| GROUP | MODEL | | |
|--------------------------|-----------------------------|--|--|
| Safety Recall Campaign | 2018-2021MY Stinger (CK) | | |
| SC196 (Rev 2, 05/13/2021 | November 2020 | | |

NEW MULTI-FUSE AND JUNCTION BOX COVER INSTALLATION (SC196/SC196A)

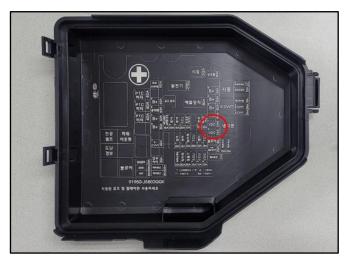
5. On the junction box, loosen the multi-fuse retaining nut.

Torque Specifications for nut: 16.6 - 19.5 lb.ft (22.5 - 26.5 N.m, 1.0 - 1.2 kgf.m)

- 6. Push the lock pin to release and remove the multi-fuse.
- 7. Install the <u>new</u> multi-fuse in the reverse order of removal.
